GM Bulletin No.: 15118A
Date: March 2016

SUBJECT: Service Update for Inventory and Customer Vehicles
Engine Block Heater Cord
Expires with Base Warranty

MODELS: 2015 Chevrolet Colorado
2015 GMC Canyon
Equipped with Engine Block Heater (RPO K05)

This bulletin has been revised to correct part number descriptions and quantities in the Part Information section, and revise steps 7, 8, and 10 in the Service Procedure. Please discard all copies of bulletin 15118.

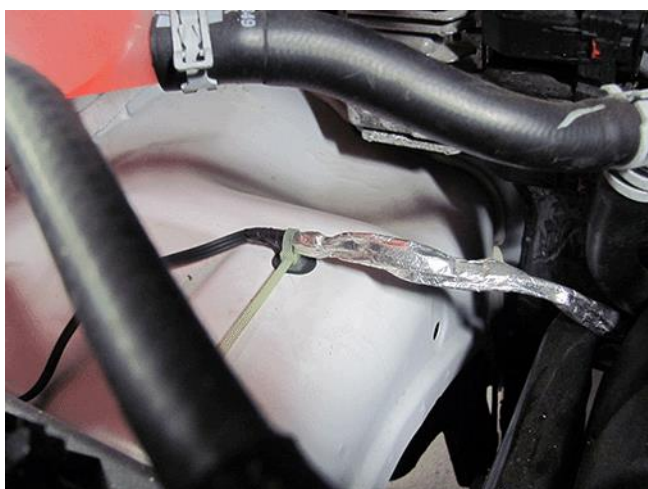
7. Install 1 oval clip (13596798) to the body as shown and attach the coolant heater cord.

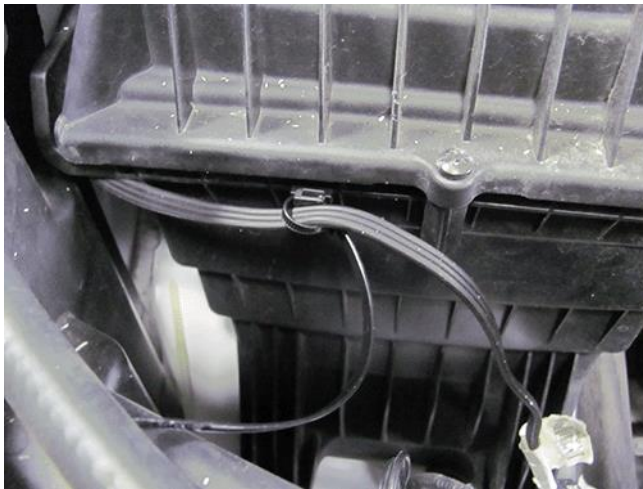
8. Loosely install one tie strap offset clip (13144735) and one oval clip (13596798) on to the heater cord as shown.

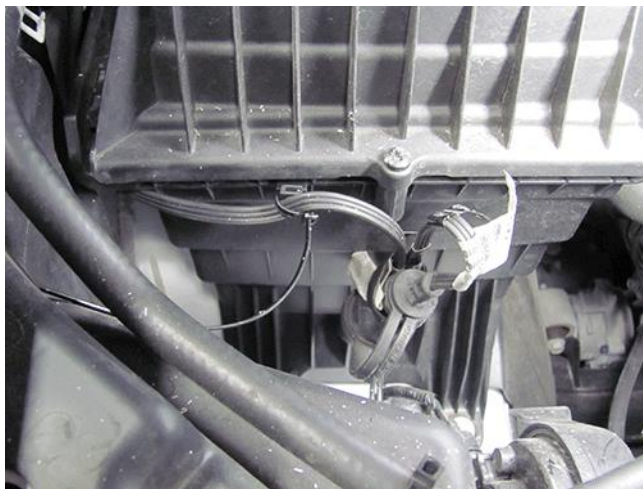
10. Install the edge clip (13596781) on the third lower rib of the air cleaner assembly and loosely secure the coolant heater cord.
